UNITED STATES PATENT AND TRADEMARK OFFICE

10/687,825

Office Action Summary

DETAILED ACTION

FIG. 5

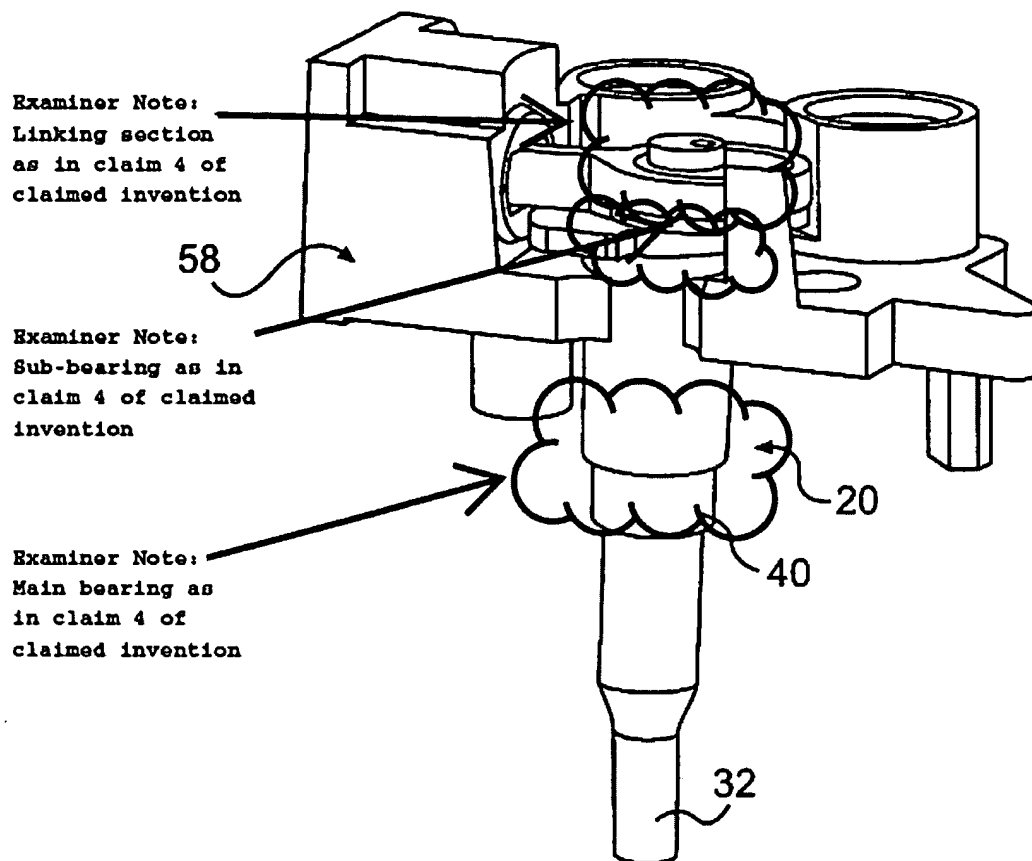
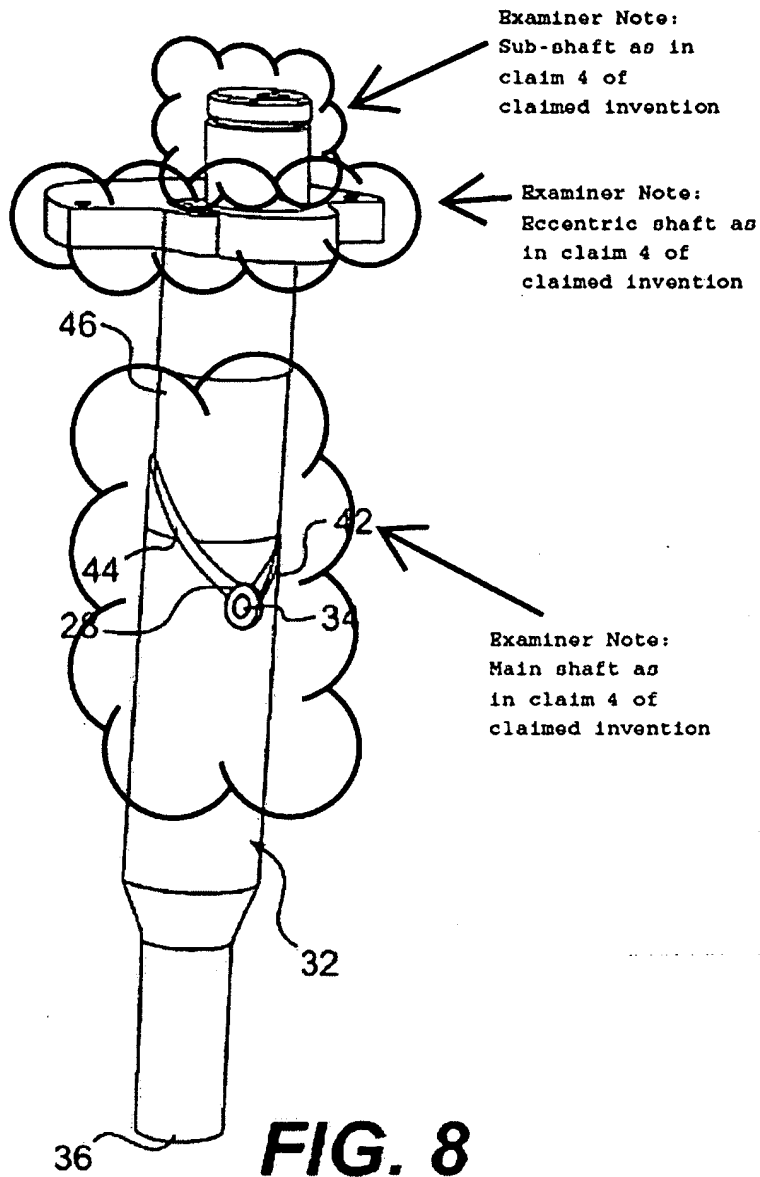
Goodnight does not teach a pair of vertical holes, functionally independent and prepared at an upper section of said crankshaft, open into said container and communicating with said spiral pumps respectively. Khoo et al. '420, with article 68 in Figure 5, does teach a single helical groove (spiral pump) that communicates with a

centrifugal pump (Khoo et al., Figure 5, article 64) disposed in the lower section of a crankshaft, and a vertical hole (Khoo et al., Figure 5, article 72) that is prepared at the upper section of a crankshaft (Khoo et al., Figure 5, article 75) and open to a container (Khoo et al., Figure 1, article 12). This method of lubricating a crankshaft within a compressor is well known within the art. Khoo et al. '420 as applied to Goodnight '561 would provide for each helical groove (Goodnight '561, Figure 8, articles 42 and 44) to be in communication with a functionally independent vertical hole. The motivation for combining the claimed inventions of Goodnight '561 and Khoo et al. '420 would be to ensure that the bearings, in contact with said crankshaft, are always properly and efficiently lubricated by facilitating a constant flow of oil from said reservoir to said bearings, regardless of the rotational direction of an active motor. Therefore it would have been obvious, to one of ordinary skill in the art, to combine Goodnight '561 and Khoo et al. '420, as applied above, to provide a lubrication system for a crankshaft that would perform (lubricate) the same, regardless of which direction the motor, of said compressor, was rotating.

crankshaft (Khoo et al., Figure 5, article 30) at an angle of theta (Khoo et al., Figure 5), which Goodnight '561 does not teach. As is stated in Khoo et al. '420, in lines 2-15 of column 4, the rate of oil that is drawn into the centrifugal pump (Khoo et al. '420, Figure 5, article 64) and therefore the total volume drawn is increased, from that of a centrifugal pump that is not disposed at a critical angle within the range of theta as shown in Figure 6 of Khoo et al. '420. Therefore it would have been obvious, to one of ordinary skill in the art, to combine Goodnight '561 and Khoo et al. '420, as applied above, to increase the rate and amount of oil that the centrifugal pump brought in and dispersed.

9. With regards to claim 3, as applied to claim 1 of the claimed invention, Goodnight '561 does not teach a vent hole communicating with said container being provided at an upper section of said centrifugal pump. Khoo et al. '420 does teach a vent hole communicating with the container of said compressor (Khoo et al. '420, Figure 5, article 76) that is displaced at the lower section of said crankshaft. This hole acts a vent to reduce the amount of air within the oil consumed by the centrifugal pump and is analogous to vent hole of the claimed invention. Therefore it would have been obvious, to one of ordinary skill in the art, to combine Goodnight '561 and Khoo et al. '420, as applied above, in order to provide a centrifugal pump, within the crankshaft of a compressor, capable of venting unwanted quantities of air from oil consumed by said centrifugal pump.
